KERR-McGEE CHEMICAL CORPORATION

HENDERSON, NEVADA FACILITY

HAZARDOUS WASTE CLOSURE/POST-CLOSURE PLAN

Deficiencies and Required  
Improvements to Closure/Post-Closure  
Plans and Cost Estimates

Figure-2

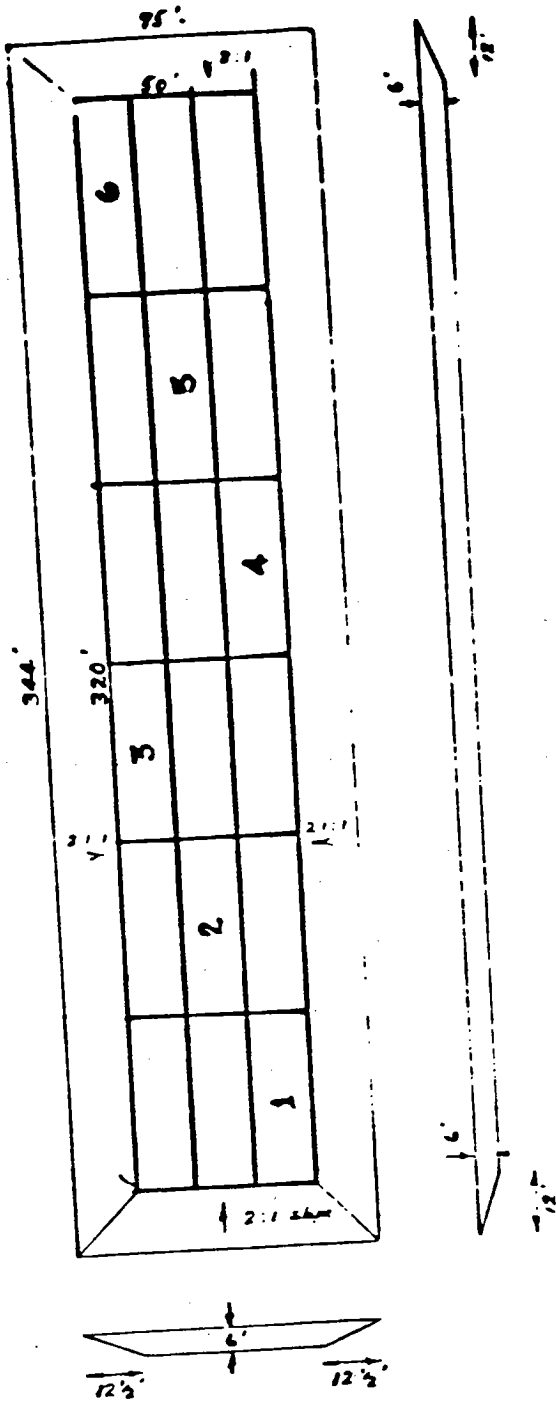
- A. After the remaining nonhazardous solids and liner are removed, six soil corings to a depth of four feet will be taken from the pond site area at locations shown in attached sketch P-1, Figure 2.
